Request For Information RFI-097

Subject: BP3 Art and Brand Wall Supplemental Steel
Project: Steamboat - BV BP Promenade and Goldwalk
Address: 2305 Mount Werner Circle
Steamboat Springs CO 80487 USA
Phone:
To: Bryan Sculthorpe
Saunders Construction, LLC
From: Saunders Construction, LLC

Subject: BP3 Art and Brand Wall Supplemental Steel
Project: Steamboat - BV BP Promenade and Goldwalk
Address: 2305 Mount Werner Circle
Steamboat Springs CO 80487 USA
Phone:
To: Stephen Carrola
Design Workshop Inc
From: Saunders Construction, LLC

2/Z50.1: ART WALL DETAIL - EAST ✓

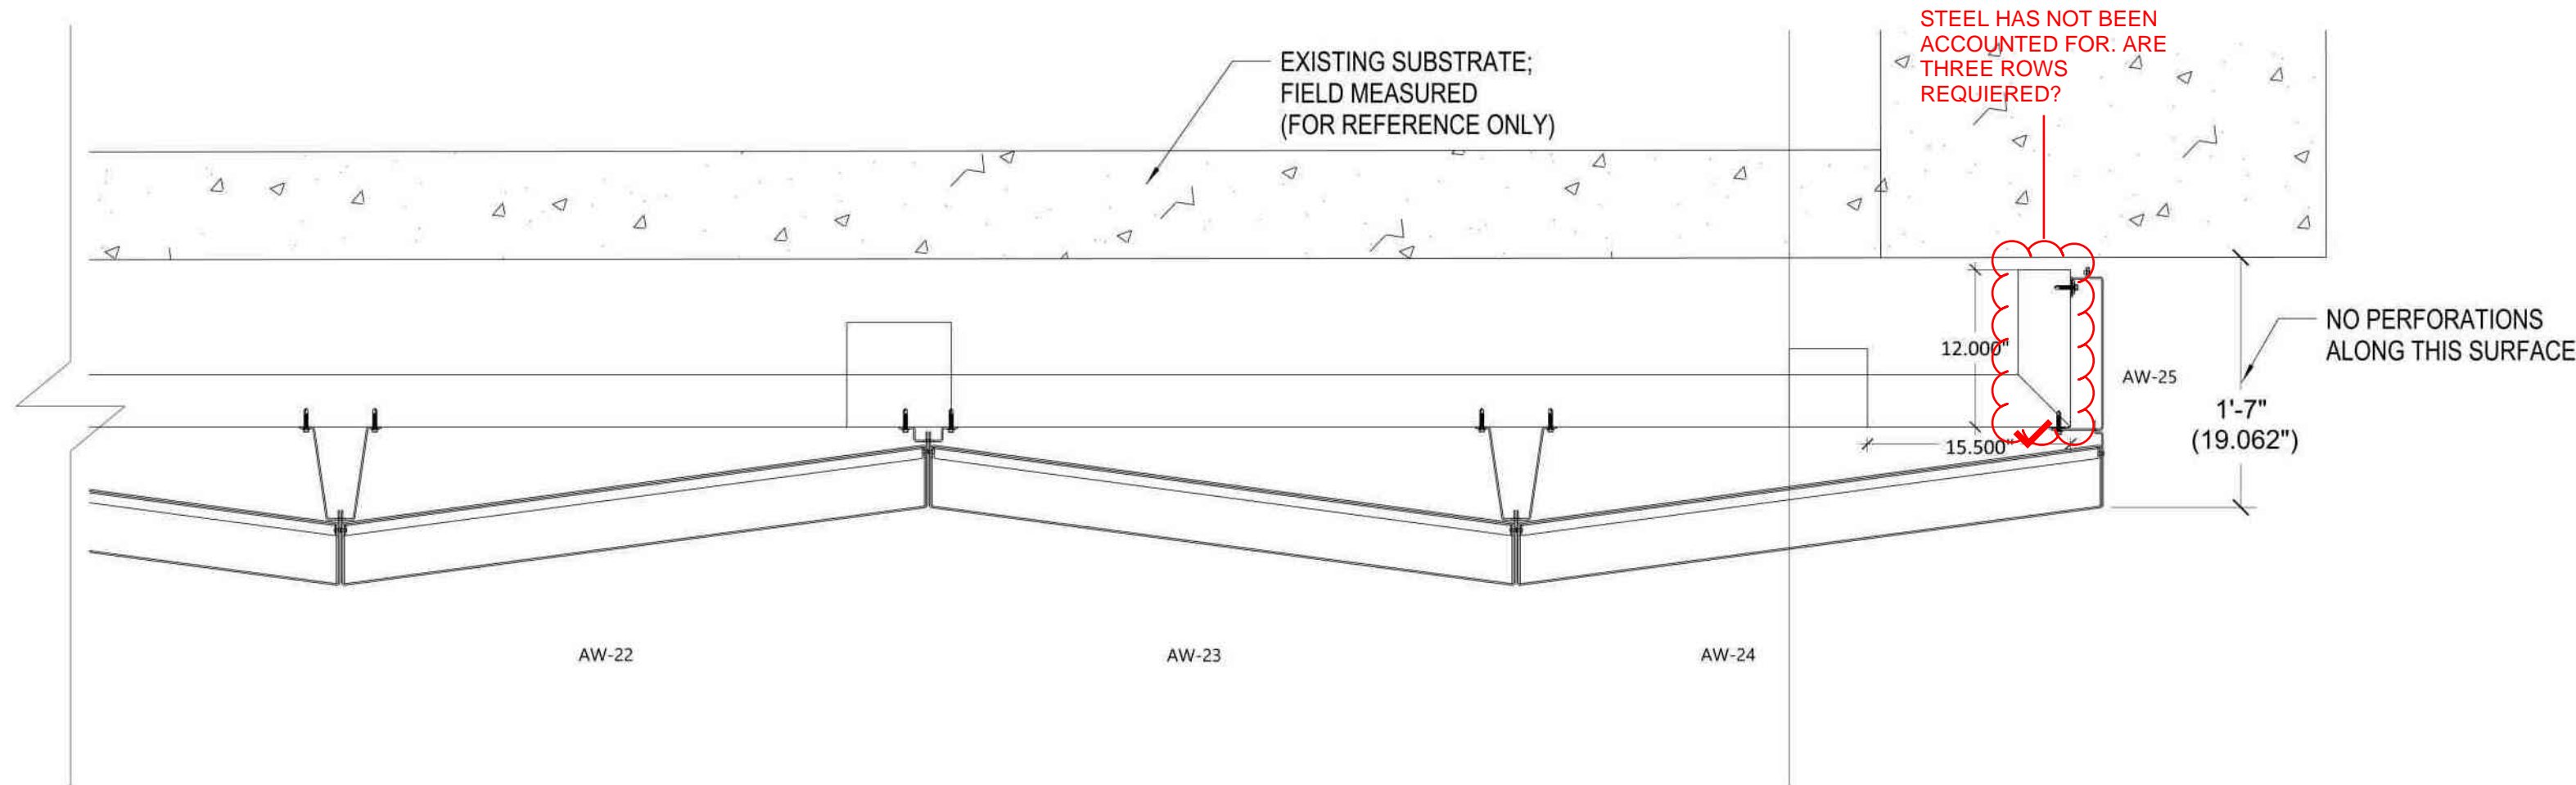
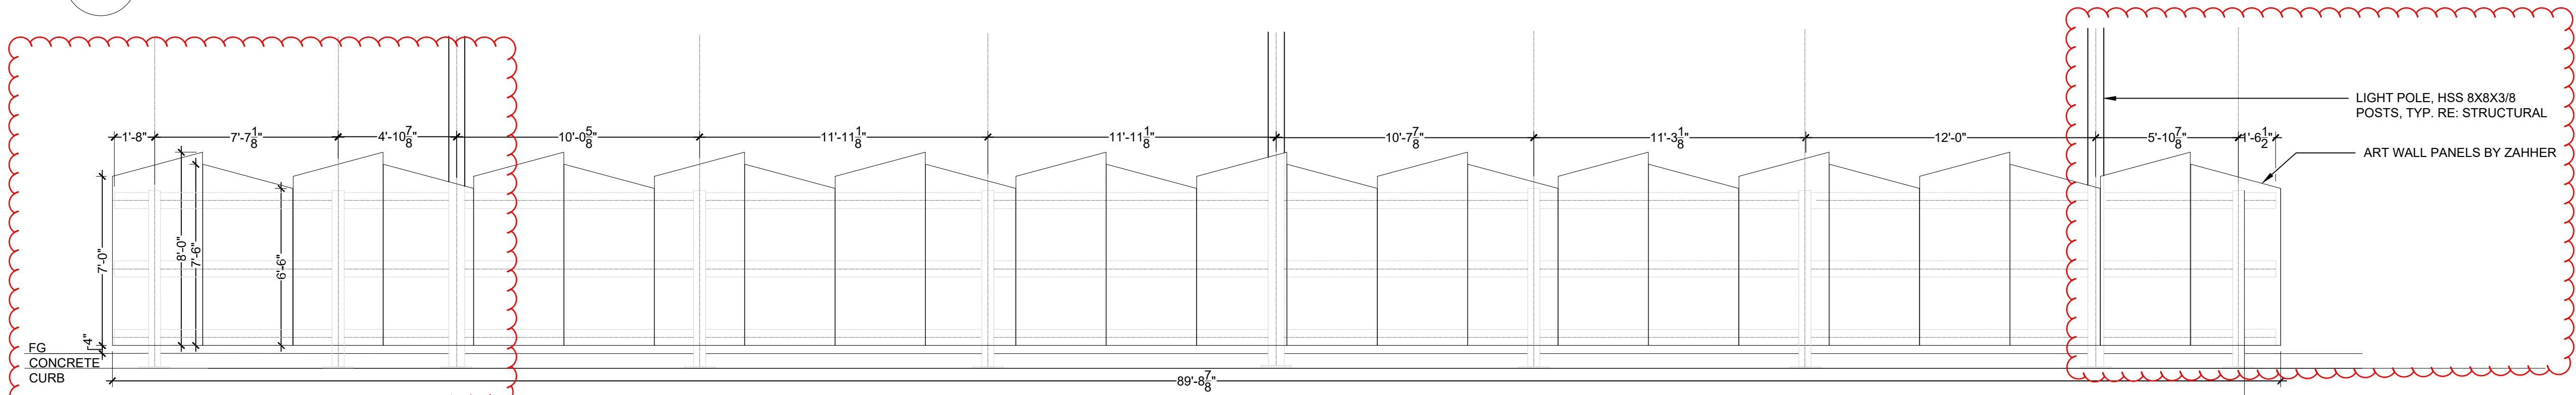
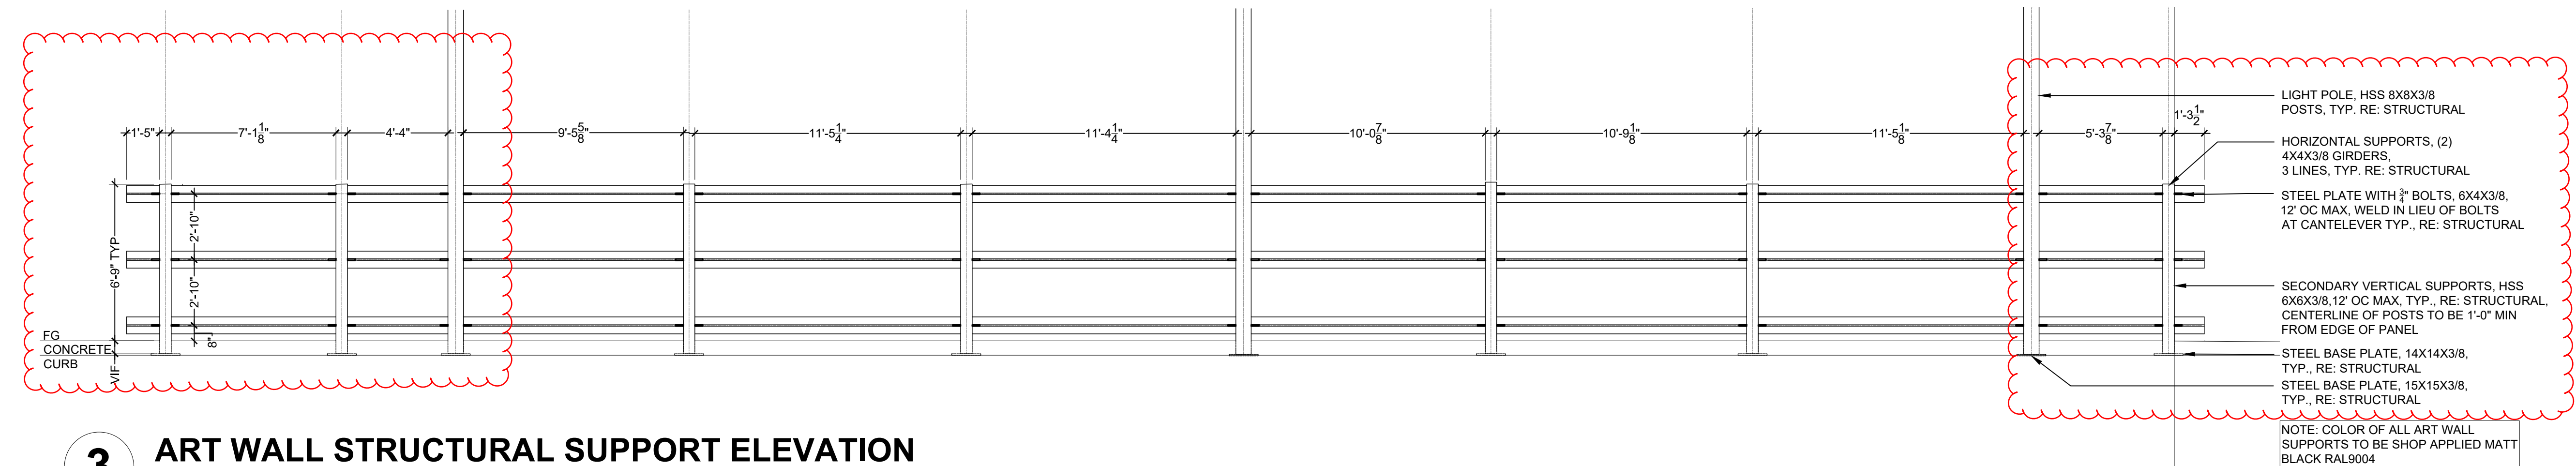
ABE, PLEASE SEE ZAHNER SHOP DRAWING TO LEFT. THIS IS THE EAST END OF THE ART WALL. WE WILL NEED TO PROVIDE GIRTERS FOR THIS END CAP. ANY CONCERNS?

No concern.
(CAC, M/M)
